ADDENDUM NO. 3

Date of Addendum: 2-10-2025

PROJECT NAME: Lake Houston Wilderness Park Cottages

PROJECT NO: WBS No F-HAR014-0001-4-01-01 ; F-HAR014-0001-4-01-02

FIRE ALARM PLAN - #12 BUNKHOUSE

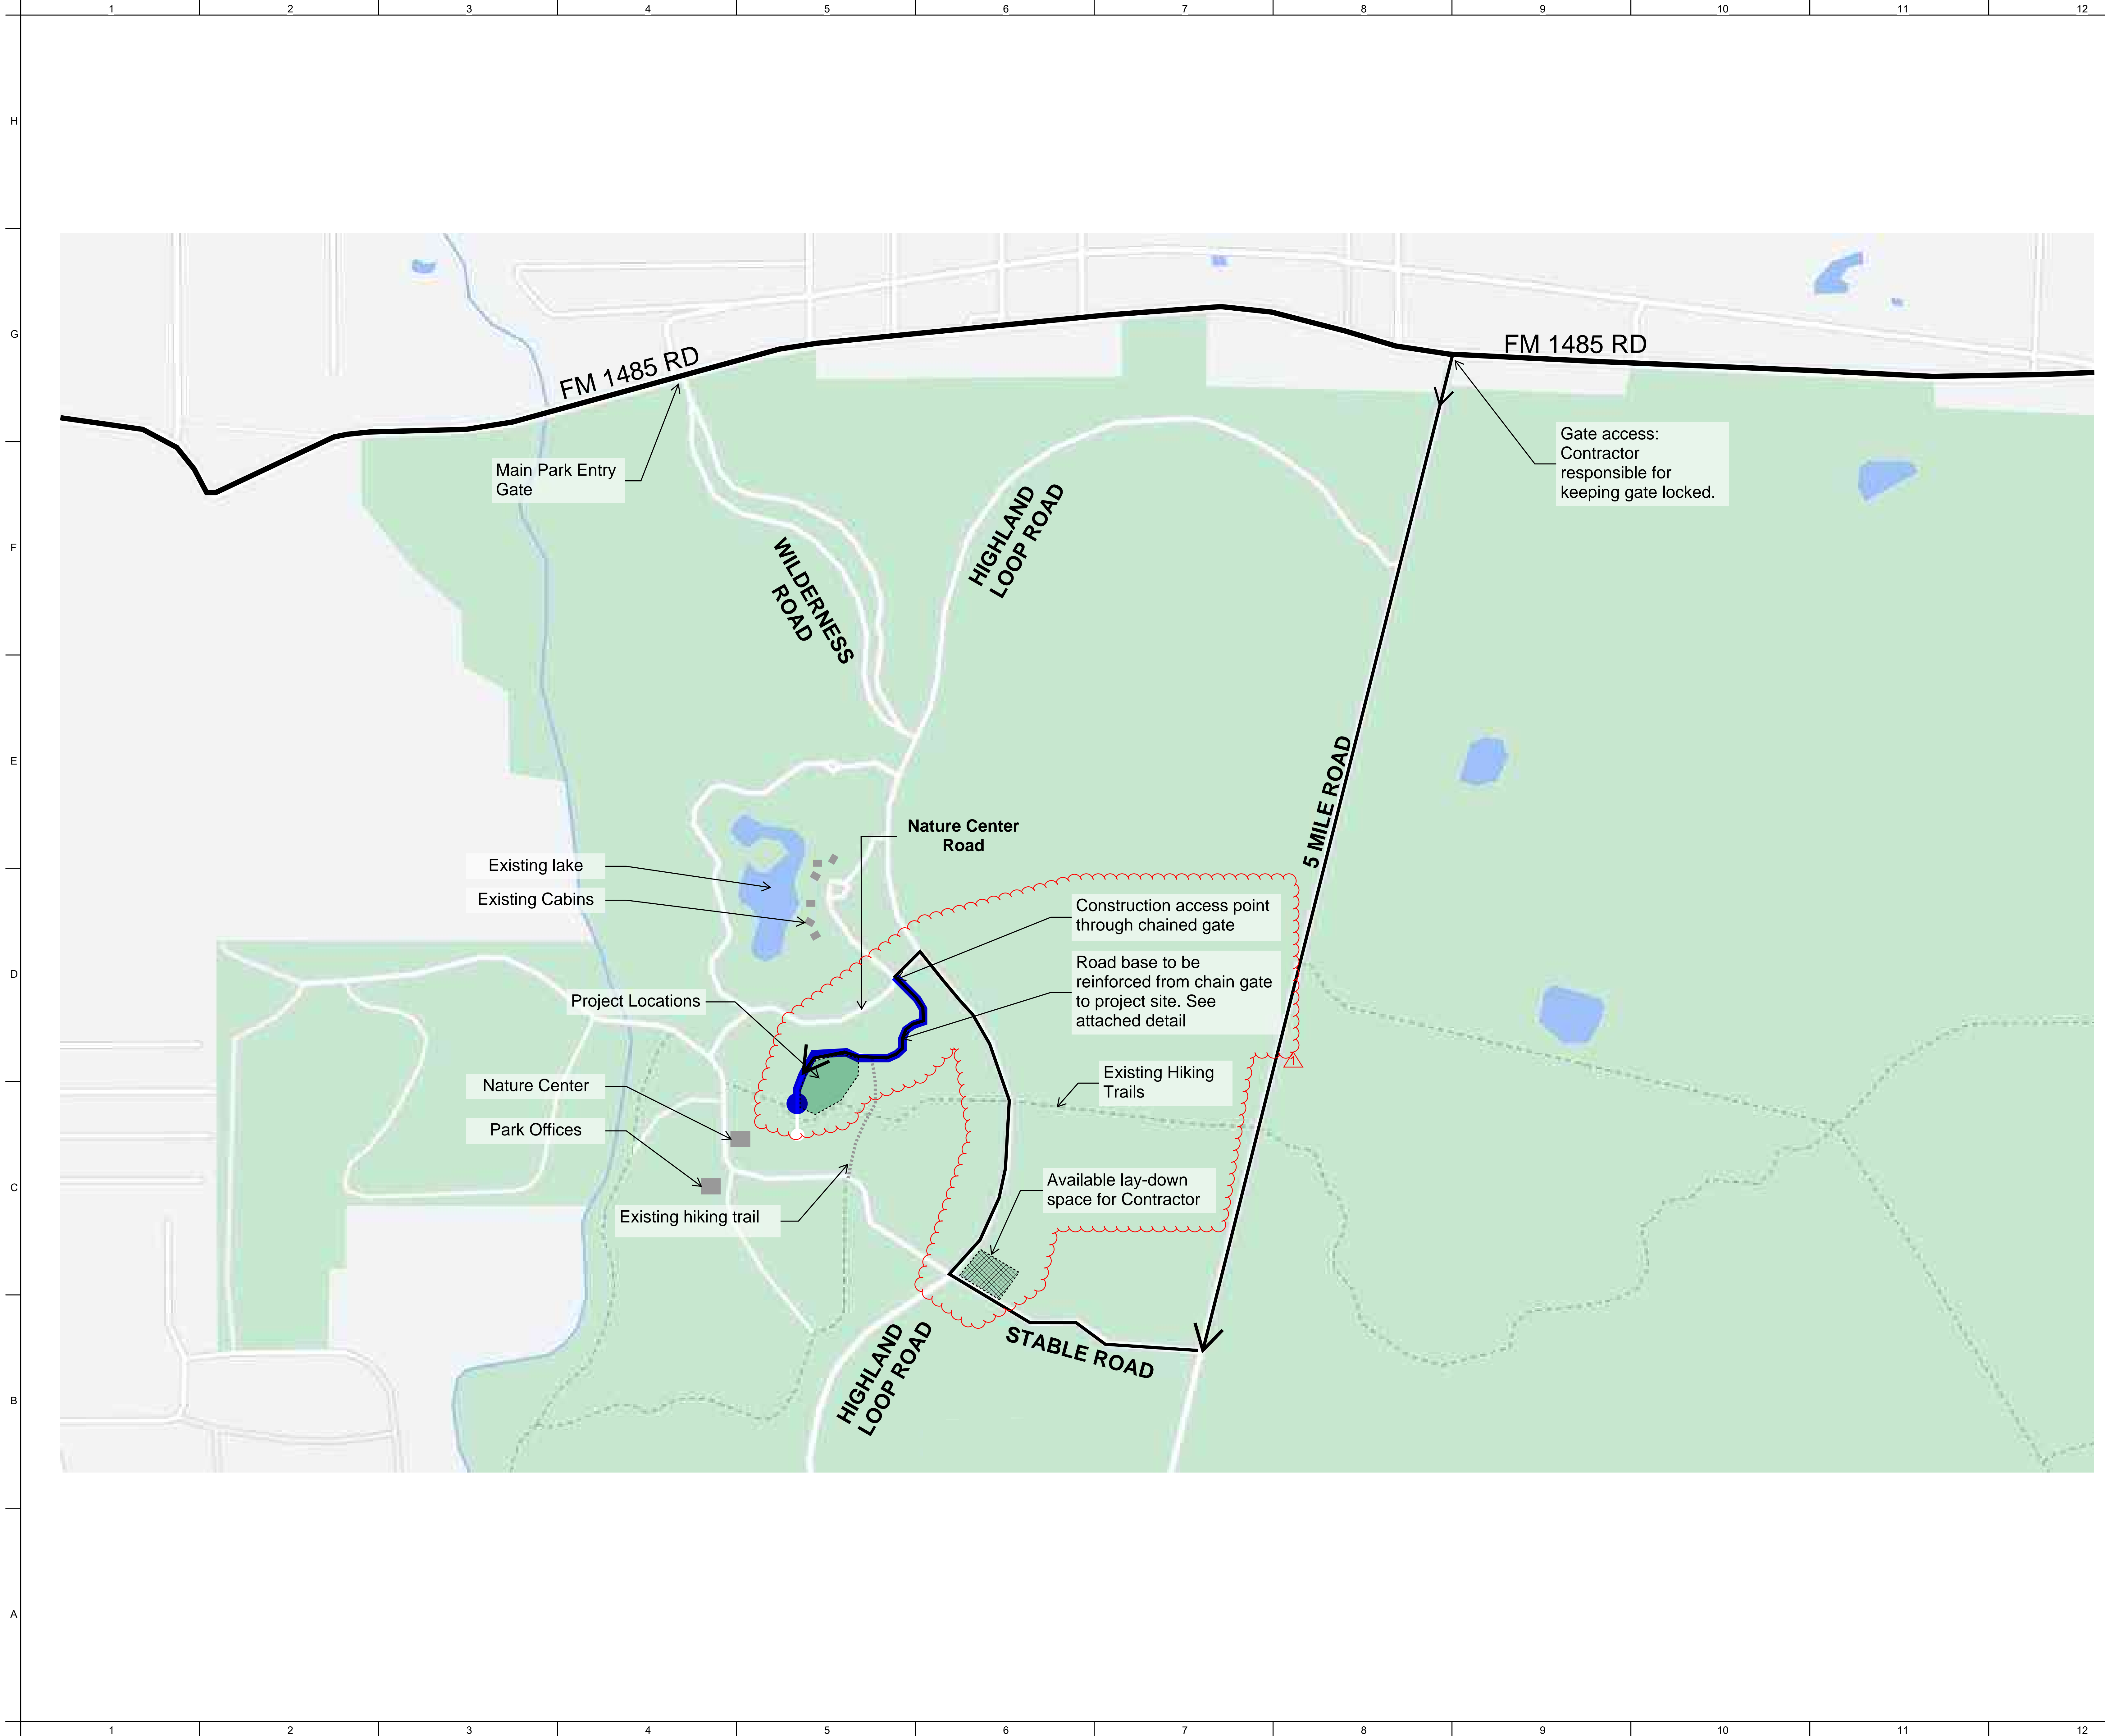
9. F1-01- FIRE ALARM PLAN - #24 BUNKHOUSE, and replace with new version to include additional fire suppression details
10. F1-02- FIRE ALARM PLAN - #12 BUNKHOUSE, Add and replace with new version to include additional fire suppression details

G0-06
SCALE:

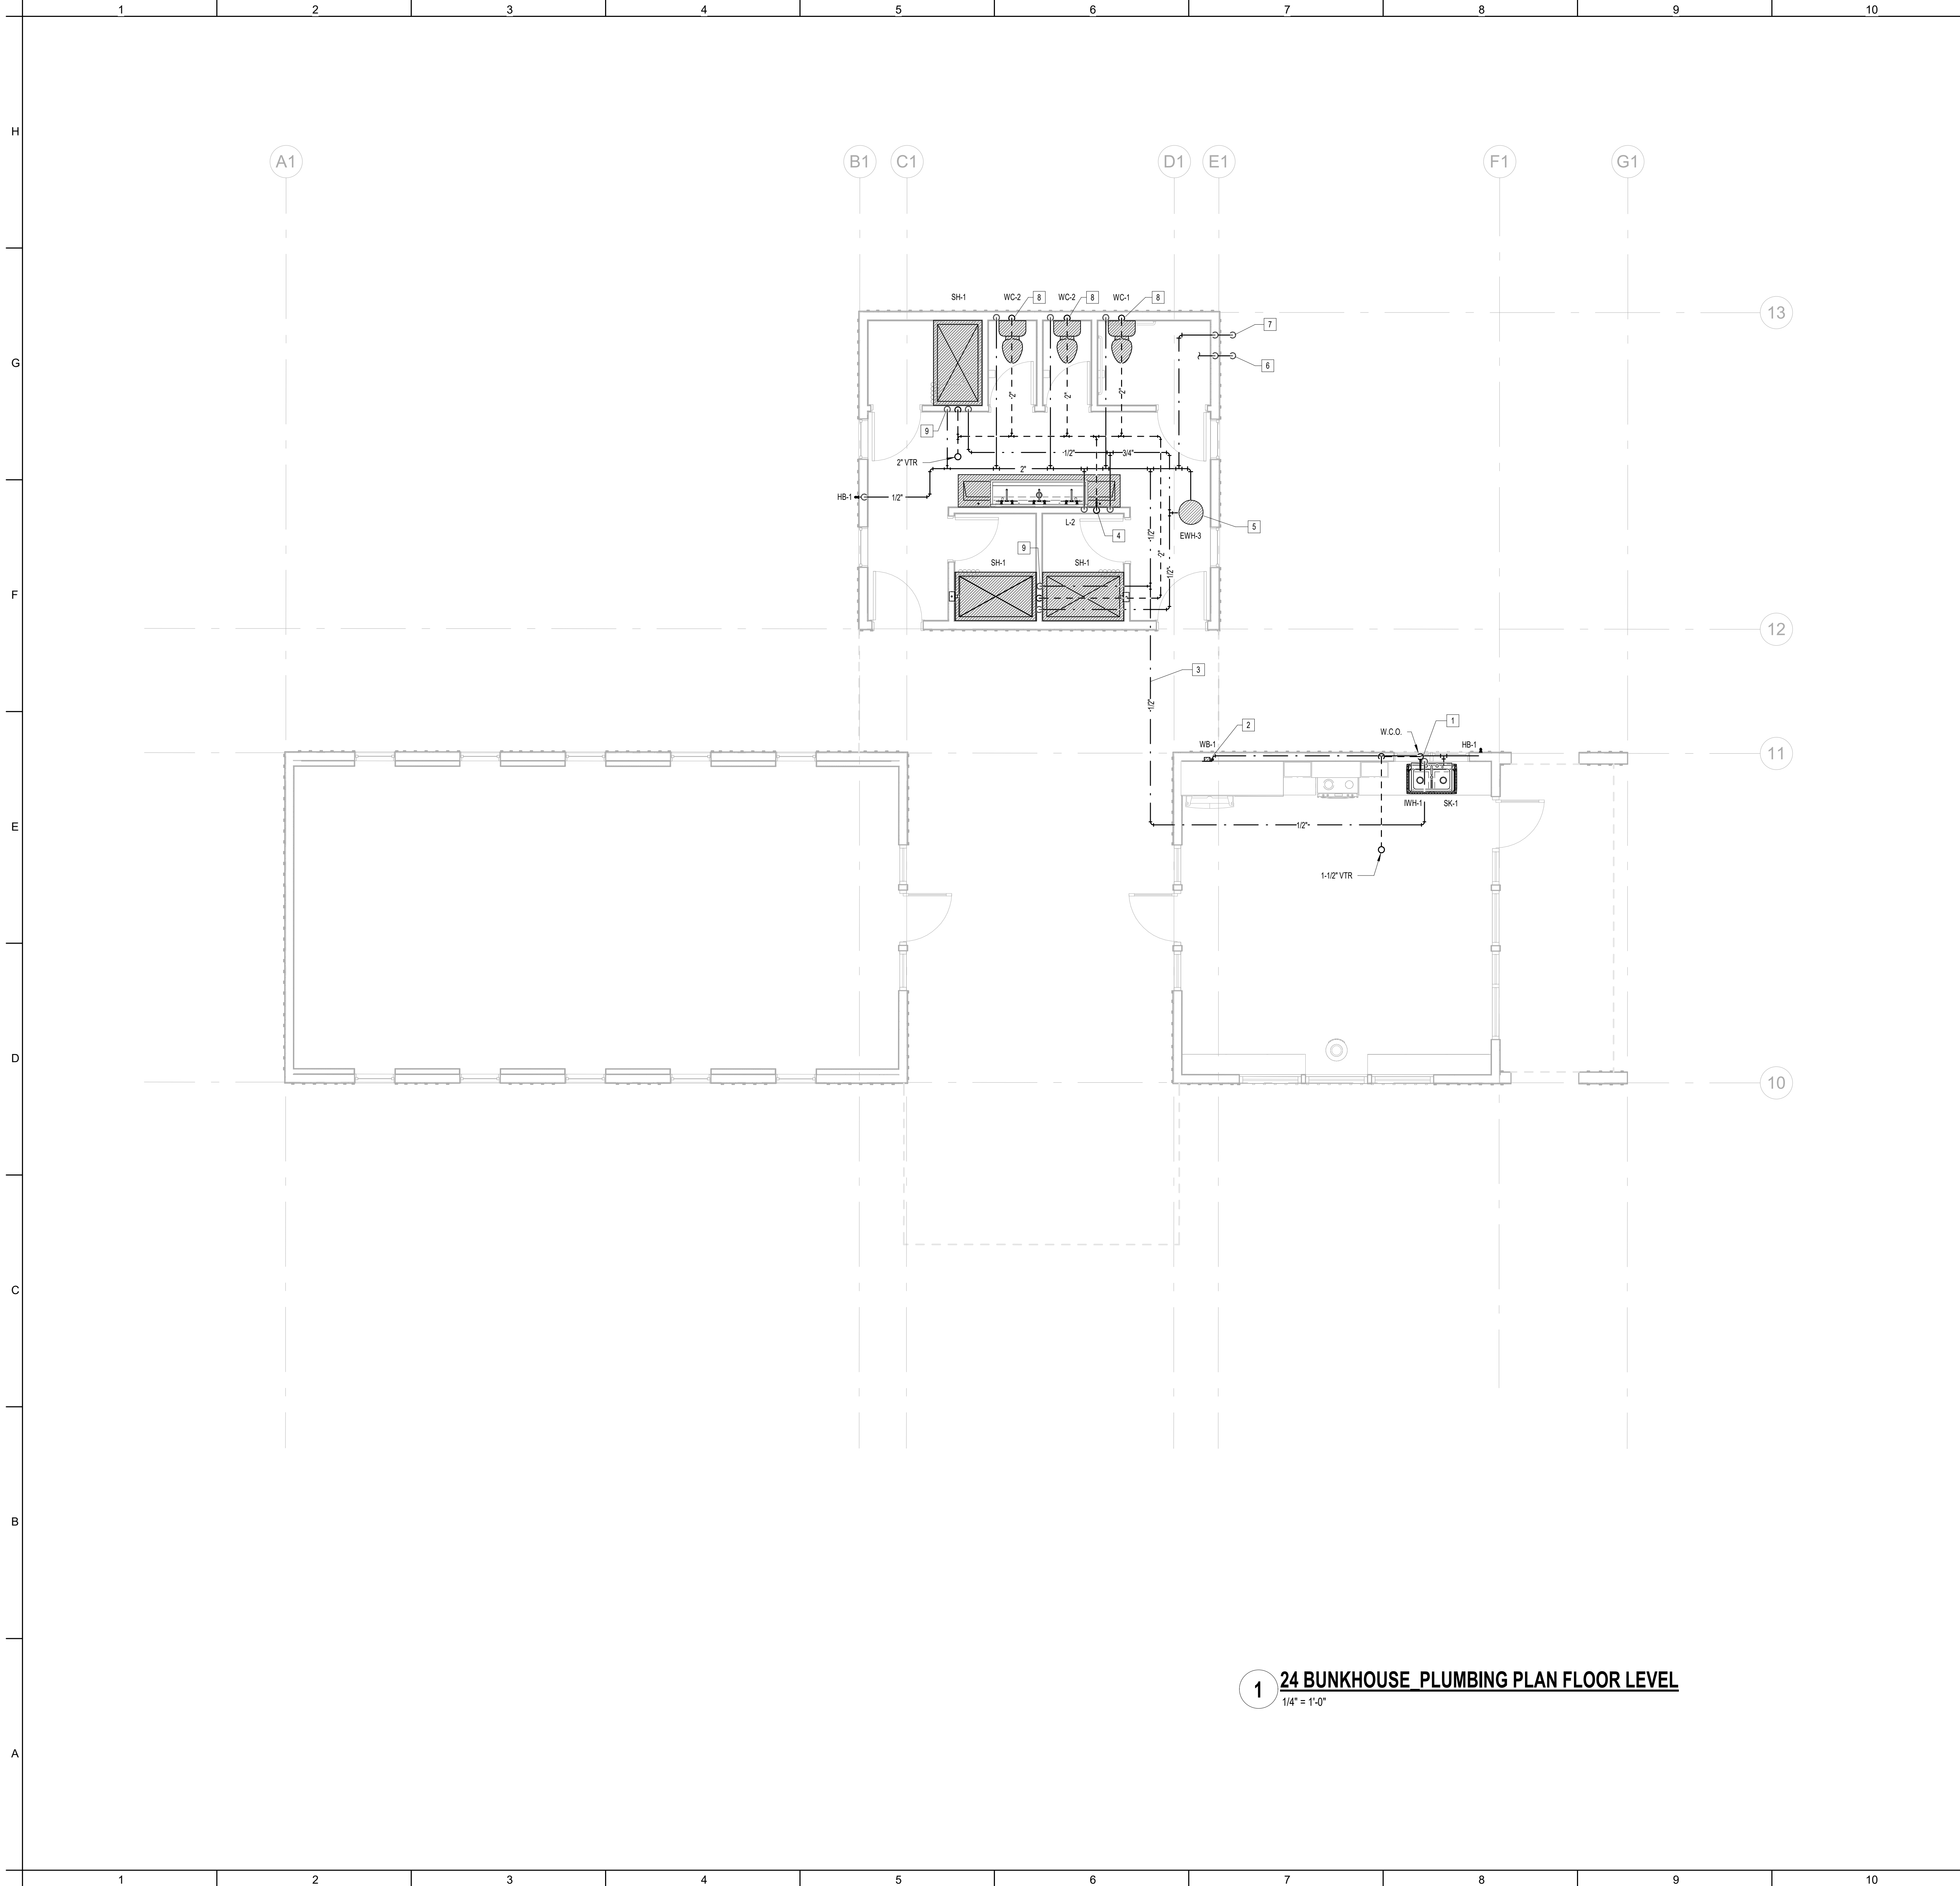
3. G0-06, SITE ACCESS, Add and replace with revised sheet which: Updated site access routes and laydown area per Bidder Site Visit.
4. C5-00 STANDARD PAVING DETAILS, Add and replace with revised sheet which: Added Detail SK-1 for Compacted Crushed Rock for access road per bidder questions referencing Sheet G0-06 note **{Contractor to provide built up stable gravel base for duration of construction for vehicular access}**.

23. Q: During walkthrough, access path changed from what is on drawing G0-06. Please confirm that we are only to build up the trail for construction access starting from the “blocked road” sign? Can you guys revise the access plan and send out?
A: You are only to build up the road from the “blocked road” sign to the end of the road where the turnaround is to be created. Delete Sheet G0-06, SITE ACCESS, and replace with replacement Sheet G0-06 SITE ACCESS as specified in “CHANGES TO DRAWINGS” section above.

25. Q: Please confirm that we are not to widen trail for access.
A: You are not to widen trail for access. Refer to Drawing G0-06, SITE ACCESS, included in “CHANGES TO DRAWINGS” section above.

27. Q: Please confirm that contractor is to bid an additional built road past construction site for a turning radius. Please advise on turning radius dimensions.
A: Refer to Drawing G0-06, SITE ACCESS, included in "CHANGES TO DRAWINGS" section above. The contractor is to create a turnaround wide enough for the largest piece of equipment/vehicle needing direct access to the building site. There is a lay down yard/staging area that has better access for large equipment.
